58 Anderson Street, Chatswood – Gateway Determination Report

Greater Sydney, Place and Infrastructure

January 2021

Department reference number: IRF20/5870

Figure 10: Draft Willoughby LEP 2012 Land Zone maps Sheet LZN_003 and LZN_004 (source: Parade Consulting)

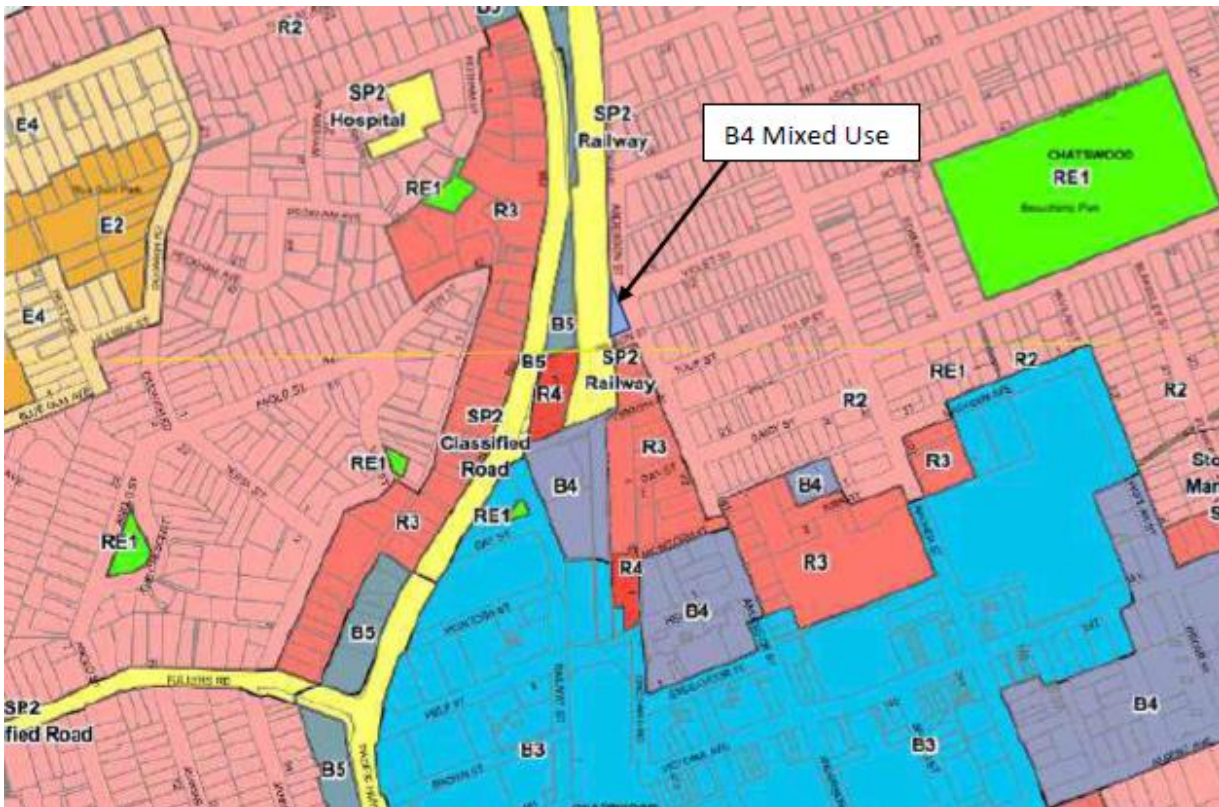
It is noted that maps 003 and 004 are both shown due to the subject site's proximity. The planning proposal, in section 4.5 Mapping refers to amendments to maps sheets 004.

The actual map sheets being amended are map sheets 003. This will require updating prior to public exhibition.

- (f) reference to map sheet 003 in lieu of map sheet 004 for the proposed maps;
- (g) removal of material discussing:
 - i. A Plan for Growing Sydney and Draft Greater Sydney Region Plan;

Figure 25: Overshadowing 12pm
(source: Drew Hickson Architects, overlay by DPIE)

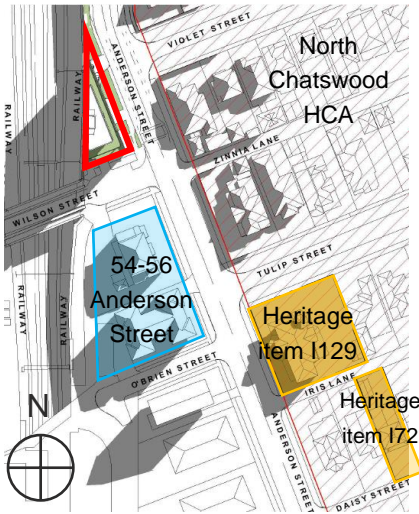
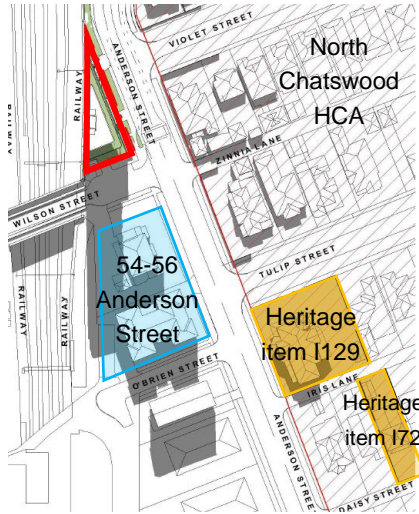
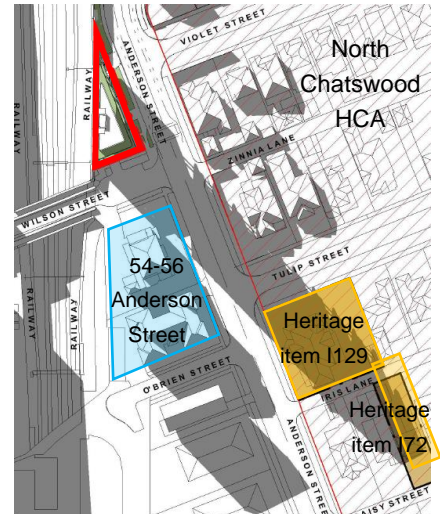
The location of the proposed development will result in overshadowing mainly to the road and railway corridor. Between midday and 3pm there will be additional overshadowing to a small number of nearby dwellings. The residential flat buildings at 54-56 Anderson Street will be impacted by overshadowing from approximately 12pm until after 2pm. The local

heritage item at 20 Tulip Street (item I129) will not experience overshadowing until after 3pm during the winter solstice (**Figures 24-26**). The slender shape of the building will ensure a fast-moving shadow to minimise overshadowing to the surrounding developments, including the North Chatswood HCA to the north and east.

Figure 31: Proposed underground floor plan with car stacker (source: Drew Dickson Architects)

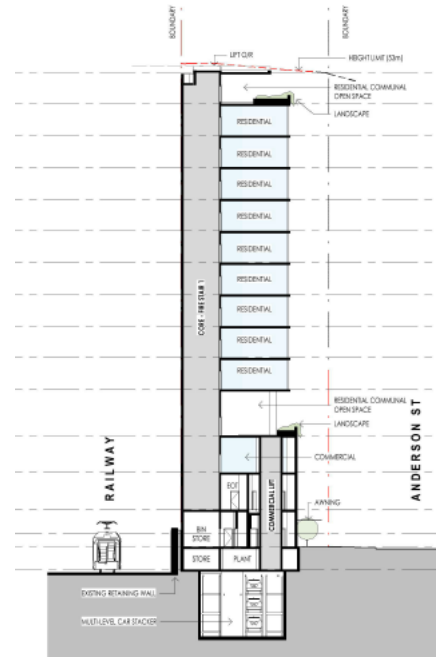
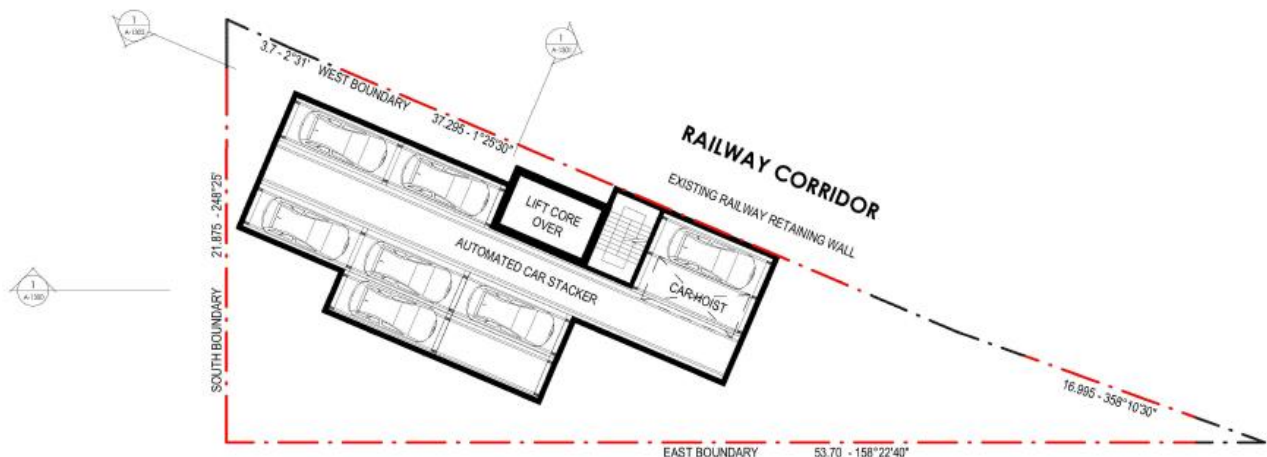
The development will provide commercial and retail with 15 residential apartments above with on-site basement carparking containing an automated car stacker for 18 vehicles and space for bicycle parking. The provision of car parking is adequate, and Council is supportive of the carparking rate below that specified in the Willoughby DCP 2016. All vehicles including servicing vehicles will utilise a turntable to be able to enter and exit in a forward direction (**Figures 17 and 29-31**).
